## ADDENDUM No. THREE

Date: November 22, 2023  
Project: LAS Expansion & Sewer System Improvements, ARPA Grant No. GA-0010529, MES No. 2020-48  
Engineer: M.E. Sack Engineering  
Hinesville, Georgia

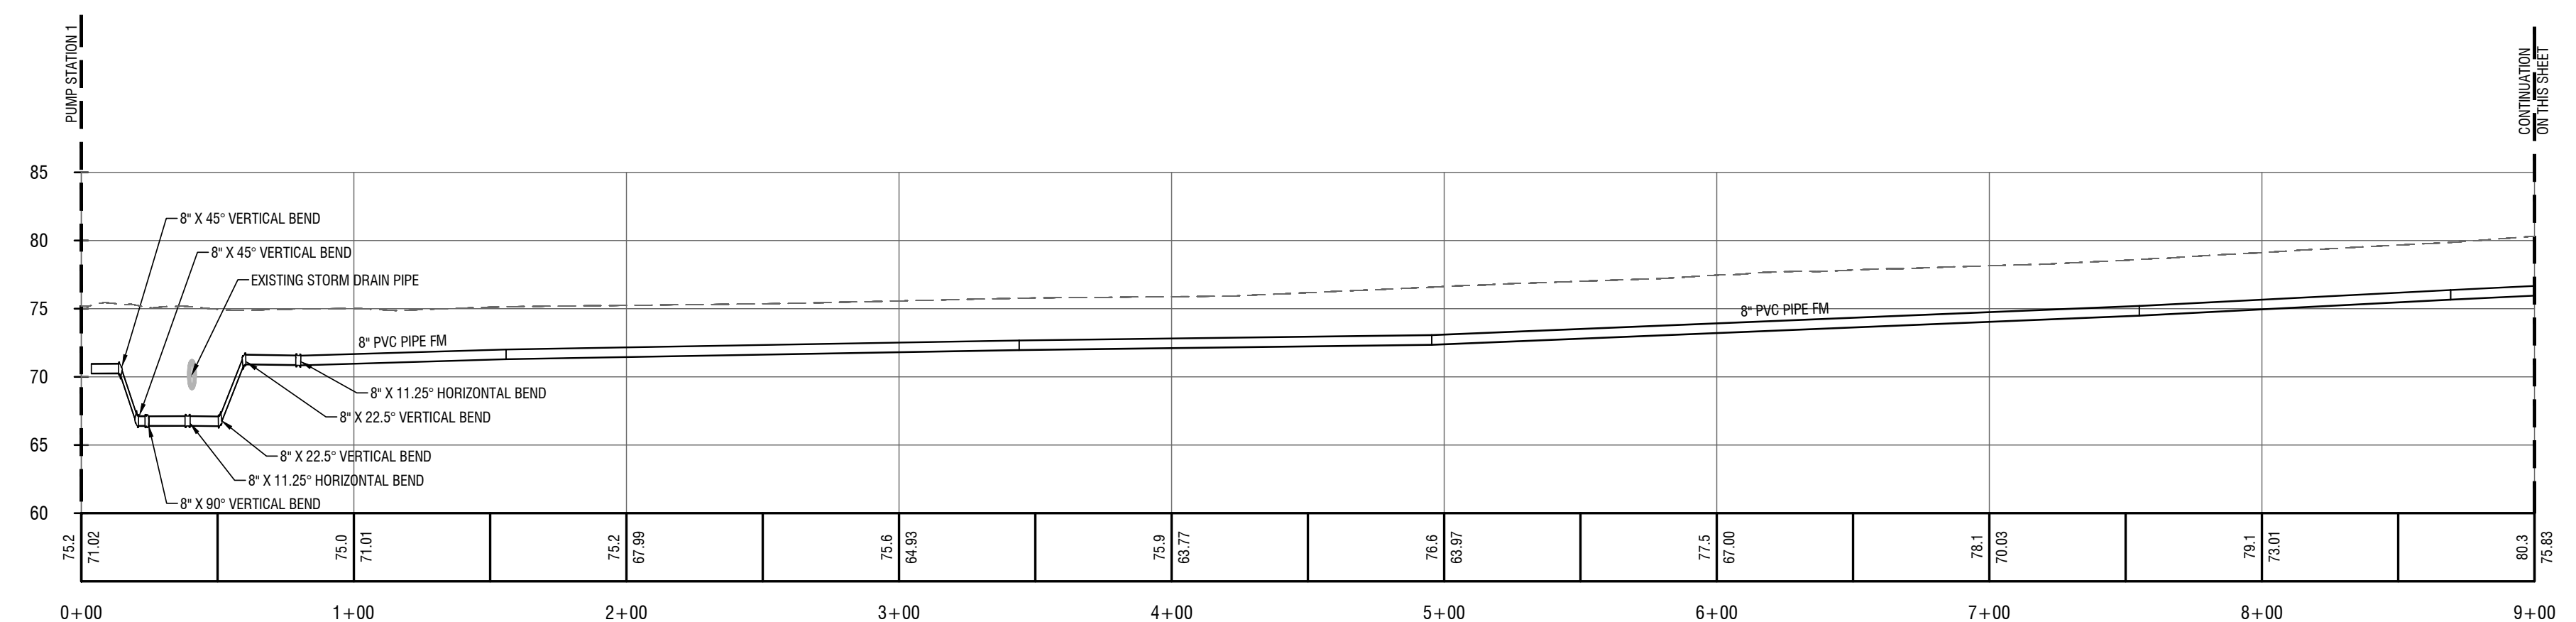
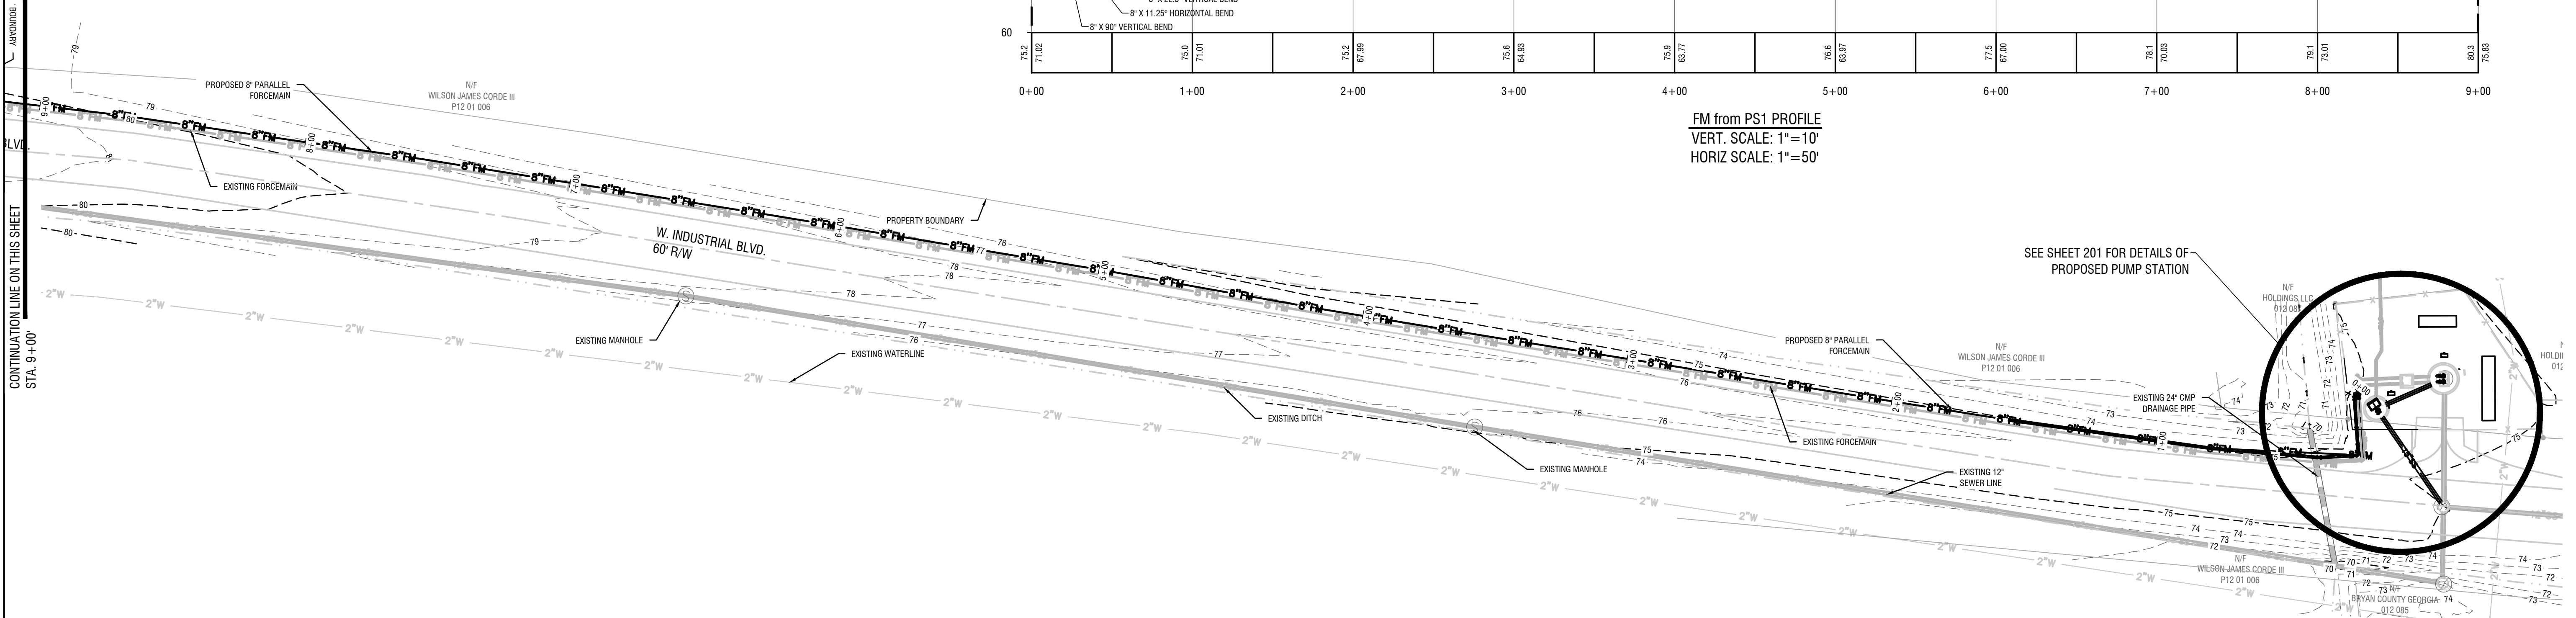
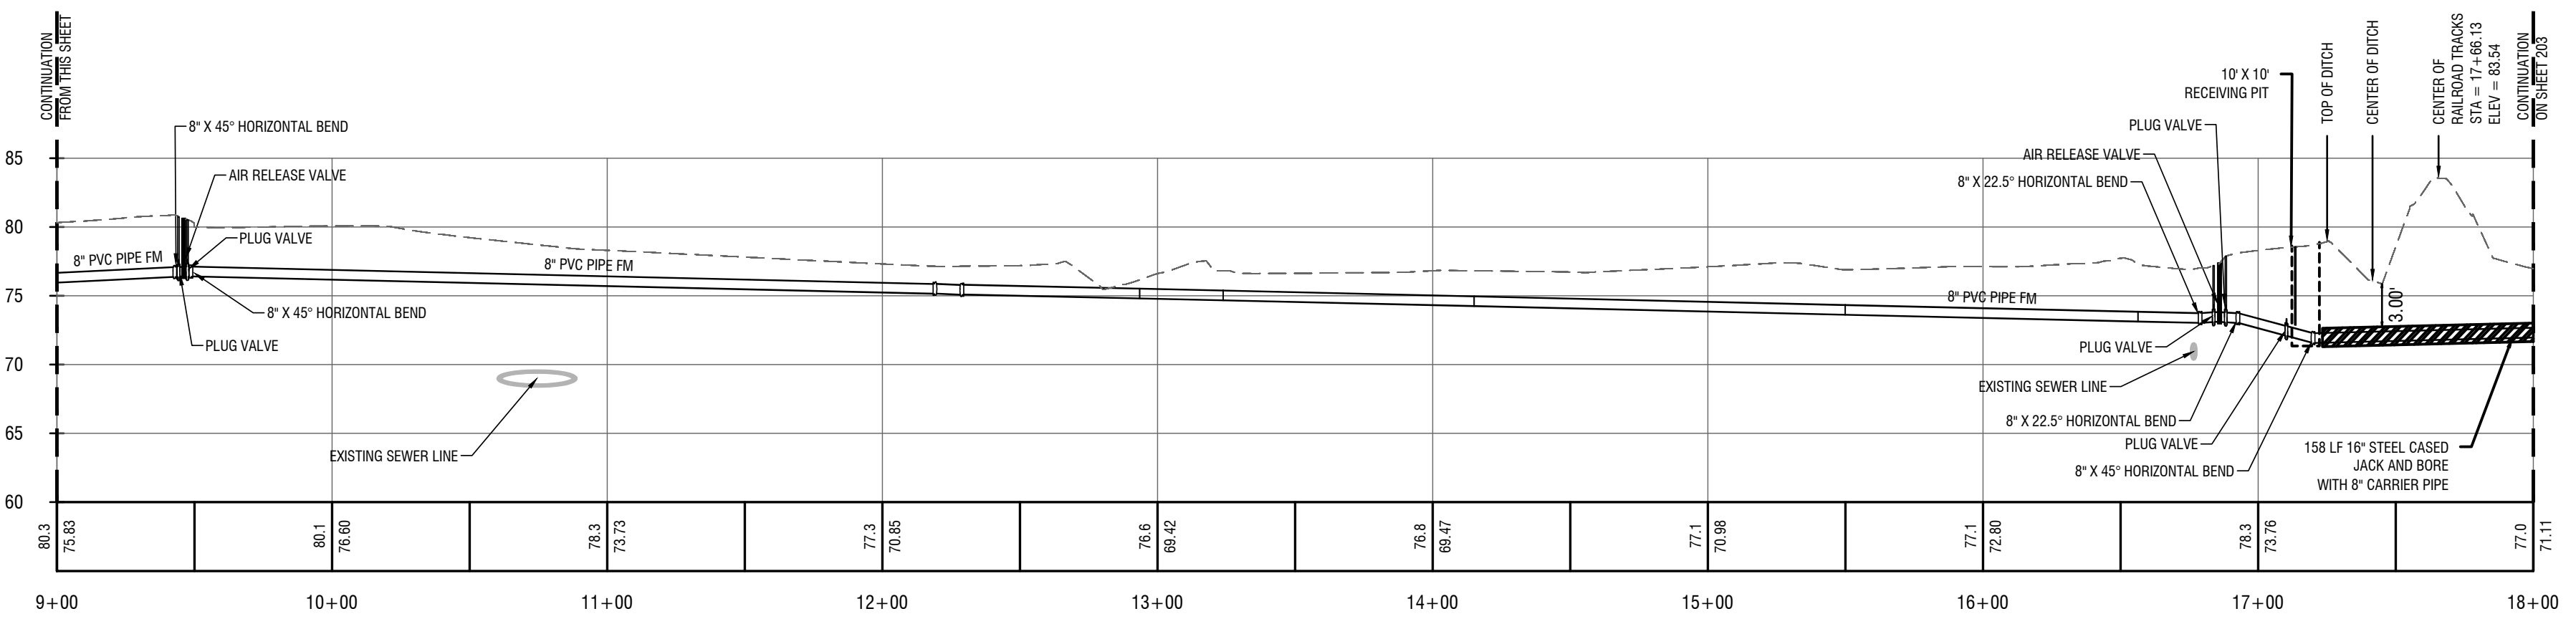
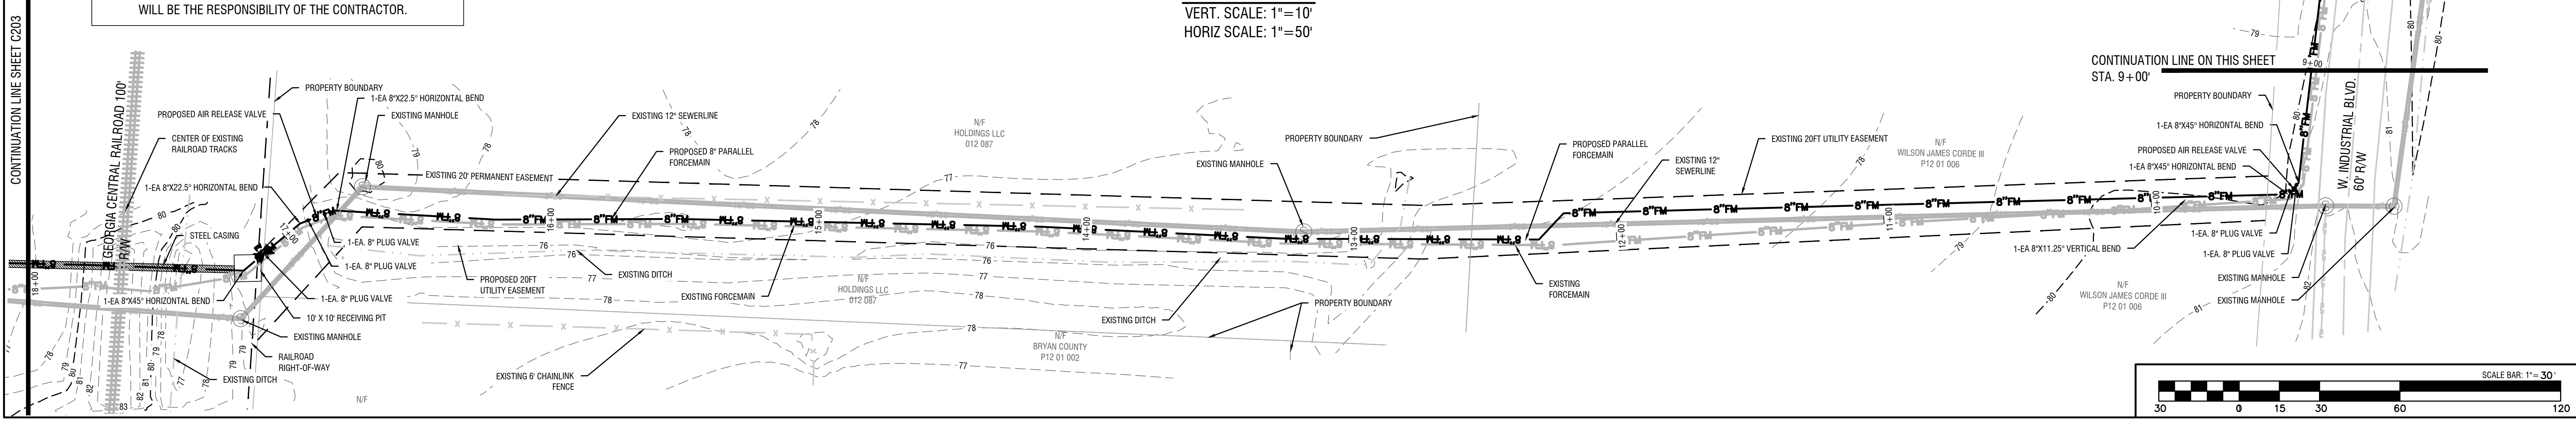
2. *To operate the dual force mains there should be additional plug valves on the force main.*
  - The plug valves were left off and have been added to sheet C201. Additionally, two were added to the bid item list (18 plug valves in total).
3. *Since the air release valve and plug valves are two line items, how should we separate the two when in the vault with the air release valve?*
  - The air release valve line item shall include the vault. Section 01150 has been updated accordingly. The plug valves shall be priced to be either stand-alone or within the vault.
4. *Will the existing valve vault at the pump station have to be removed and reinstalled to accommodate the new 15" line from the dry pit?*
  - Yes. This price shall be included in the pump station complete work. A note has been added to sheet C201. Note: Sheet C201 had notes that went off the page; these have been corrected.
